# Verdant Minerals Pty Ltd Ammaroo Phosphate Project - EIS Supplementary Report

August 2018

The EIS was circulated to agencies and available for public comment. A total of 150 written submissions (e.g. comments) on the EIS were received from NT Government advisory bodies and agencies, and two non-government organisations.

Figure 3-1 Down-gradient concentration of a plume

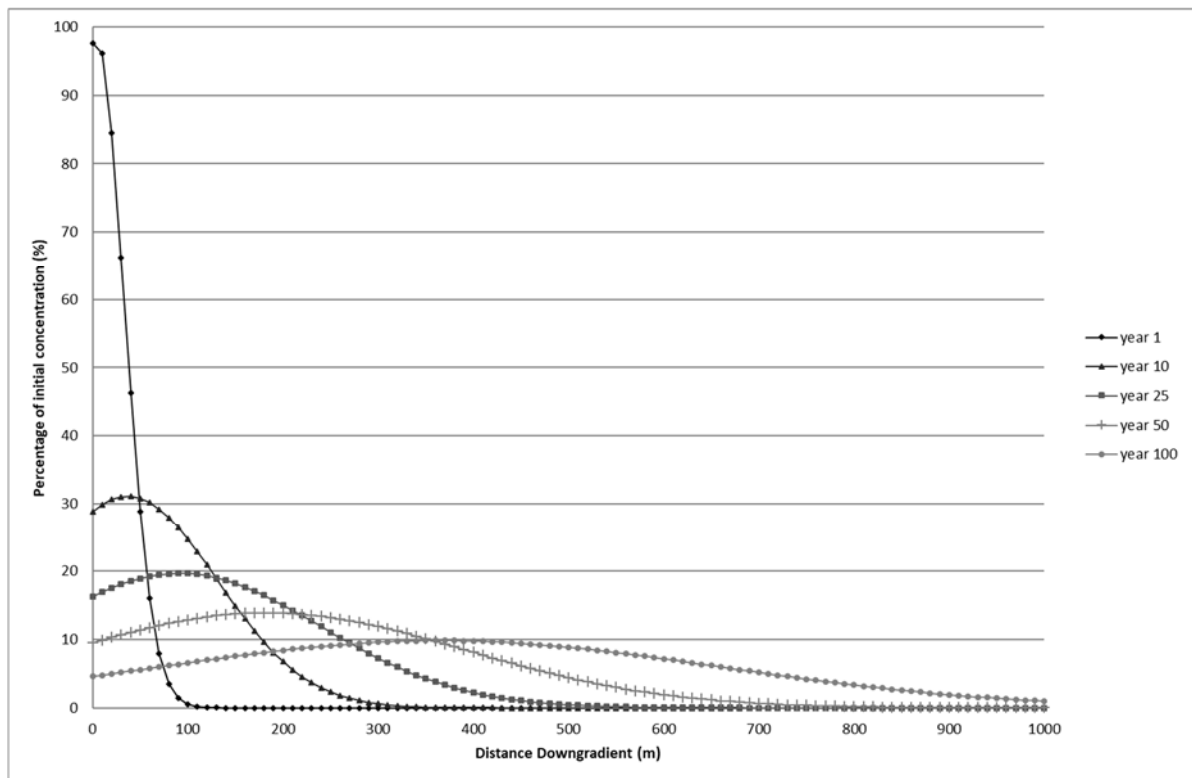
30	NT EPA	Tailings Seepage – Chemical impacts of tailings	Appendix H – Ammaroo Phosphate	<p><i>Saline tailing seepage will not be generated due to the low salinity of process water.</i> (p.38).</p> <p>Provide details of future tailings leachate test work to confirm seepage from tailings would not be saline.</p>	<p>Further test work of synthetic tailings was undertaken in December 2017 and confirms the low contaminant concentrations for a range of leaching solutions. Further information is available in Section 3.1.1. A copy of the SGS Report is provided in Appendix 8.</p>

The calculated down-gradient concentration of tailings leachate is presented as Figure 3-1. The plume moves very slowly due to the low hydraulic conductivity of the basement rock and the

Figure 3-2 Tailings dry density – moisture content relationship

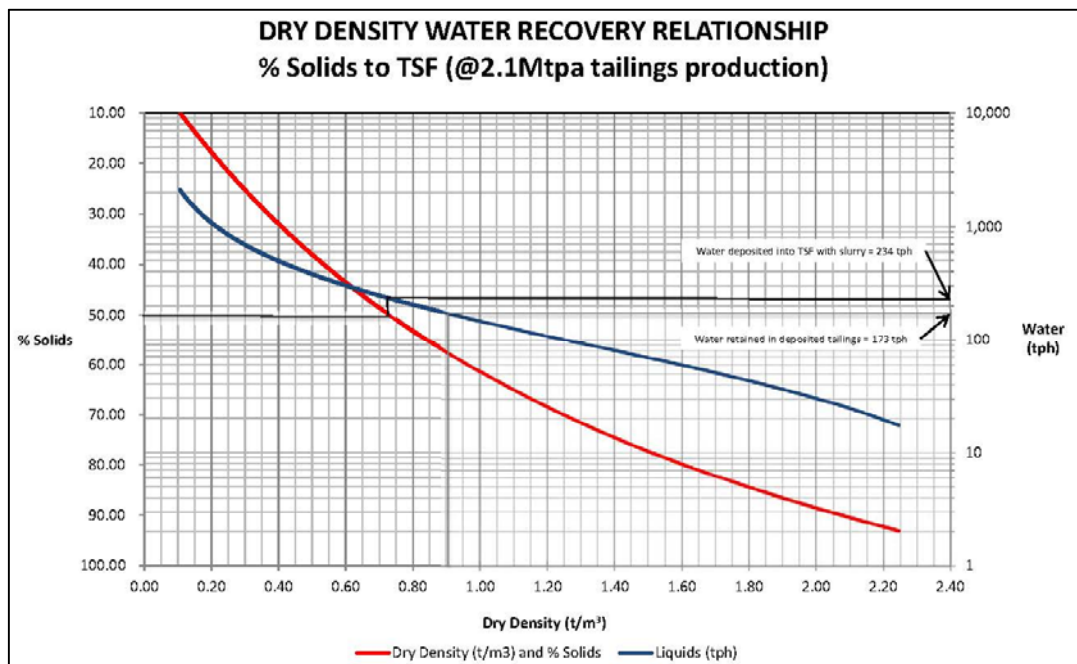
No.	Agency	Topic	EIS section	Comment (Submission)	Response
4	NT EPA	Surface Tailings storage facility design and operation	Chapter 2: Project Description 2.6.1 Table 2-9 – TSF concept design parameters	<p><i>The slurry (concentration approximately 40% water) then flows out of the raiser and forms its own beach slope which then dictates the future slurry flow patterns and water recovery at the toe of the impoundment wall</i></p> <p>The NT EPA recognises the Proponent has committed to water recovery of 20-30% of the water discharged in the tails. Provide information on options to reduce quantity of water in the slurry to further minimise water consumption.</p> <p>Table 2-9 indicates slurry density is 40% solids</p> <p>Clarify the percentage solids for the slurry density – 40% or 60%.</p> <p>In section 2.10 VRM has committed to conducting test work to establish the capacity of the tailings water to separate from the tailings and the capability to extract/recover this water from the tailings facilities, using pumps.</p> <p>Clarify that current water recovery from the tailings is able to achieve 20 -30 % or is achieving this rate of water recycling subject to this further test work.</p>	Refer to Section 3.3 for further information on tailings slurry density and water recovery.

The relationship between the dry density of the tailings and the moisture content, for a tailings production rate of 2.1 Mtpa, is presented in Figure 3-2.

**Groundwater Monitoring Plan  
Borefield Drawdown Monitoring  
Figure 3-16**

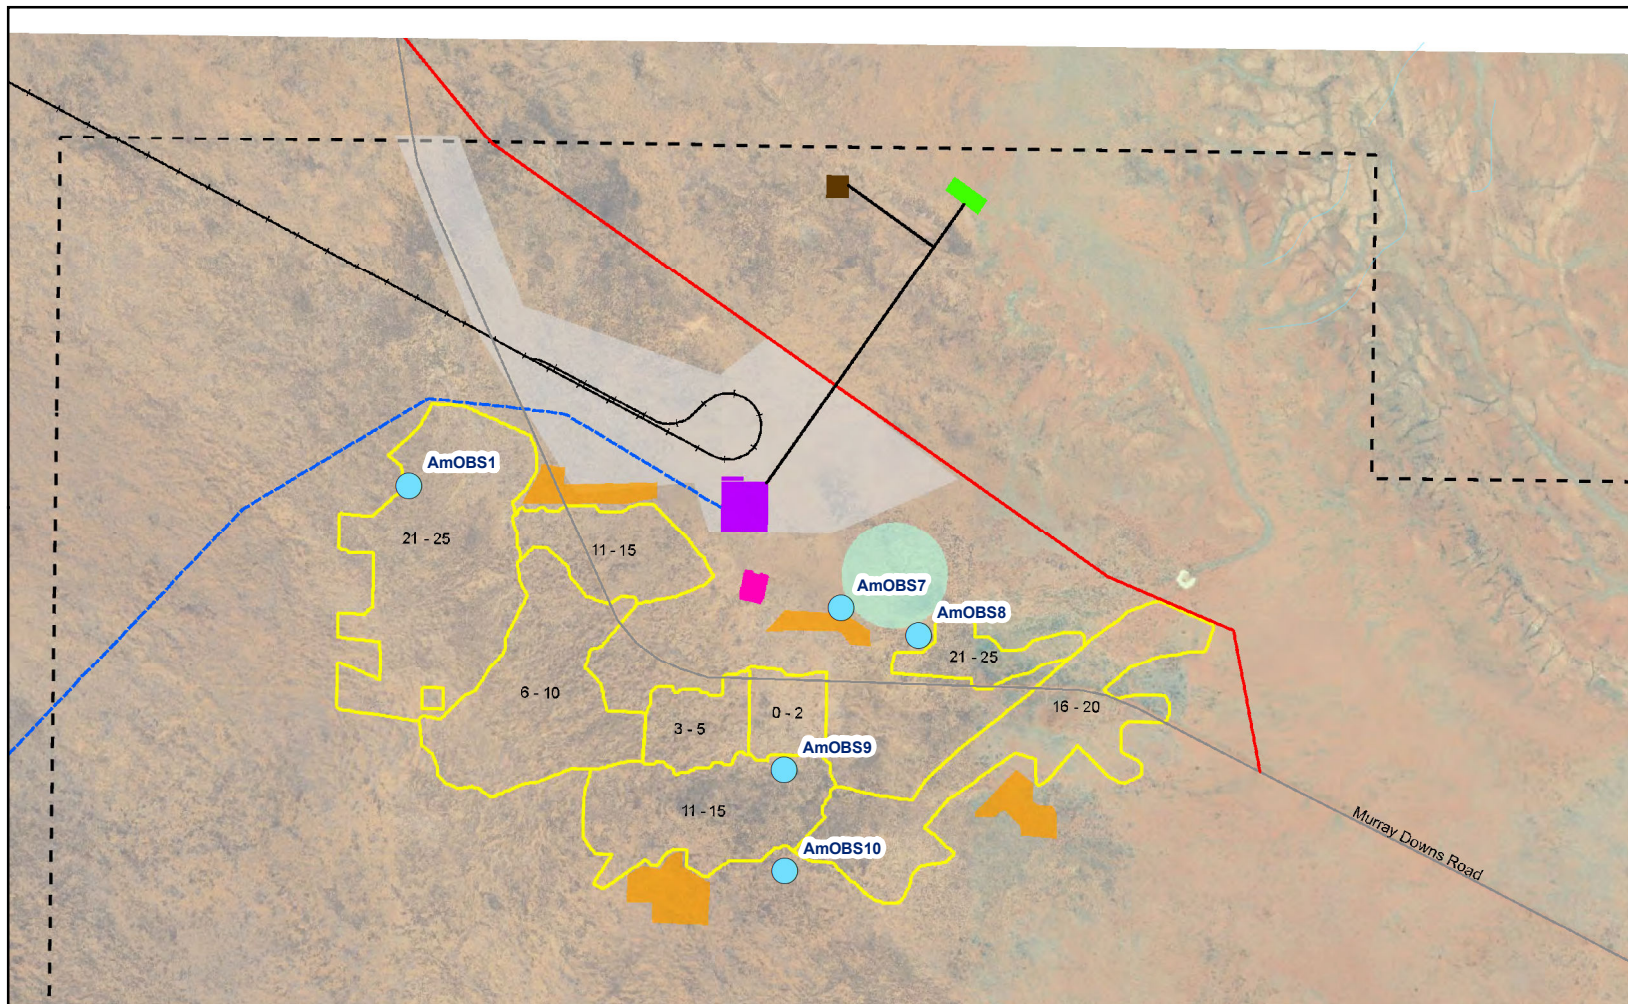
69	Department of Environment and Natural Resources, Rangelands, Water Resources and Flora and Fauna Divisions	Water resources Groundwater Monitoring	Section 6.2 Appendix H	<p>Monitoring is proposed by Verdant; however, it appears that this is yet to start. Although specialist monitoring bores are proposed (Section 6.2, Table 7, Figure 22), no mention of when these bores will be drilled, how they will be constructed etc. is presented. This is less than desirable as monitoring should begin before a mine starts not after; this way any changes from the pre-mining situation can be assessed.</p> <p>The monitoring program proposed by Verdant (Section 6.2) is considered inadequate. The monitoring bores are only proposed within the predicted area of drawdown from the borefield, no Verdant monitoring bores are proposed to be drilled beyond the predicted impact area (Figure 22). Furthermore, the reliance on existing stock or station bores as observation bores both beyond and within the predicted impact area is not adequate as access and suitability of bore conditions cannot be guaranteed in such bores. Purpose built dedicated monitoring bores is the usual expectation for monitoring points for groundwater appraisals.</p>	<p>The monitoring implementation schedule is detailed in Section 4.5.2 of the Water Management Plan (refer Appendix 6) and described in Section 3.19.2 of this supplementary report.</p> <p>Purpose built monitoring bores adjacent other users (e.g. Stock, Station and Community bores) will be located 200 m from the third-party users bore. Details are provided in the Water Management Plan. Section 4.5.1 and Section 3.19 of this Supplementary Report. Maps are shown as Figure 3-16 and Figure 3-17.</p>

Groundwater monitoring to measure the impact of borefield pumping is detailed in Table 3-35 and Figure 3-16. The monitoring network comprises 14 observation bores extending out from the borefield in all directions.
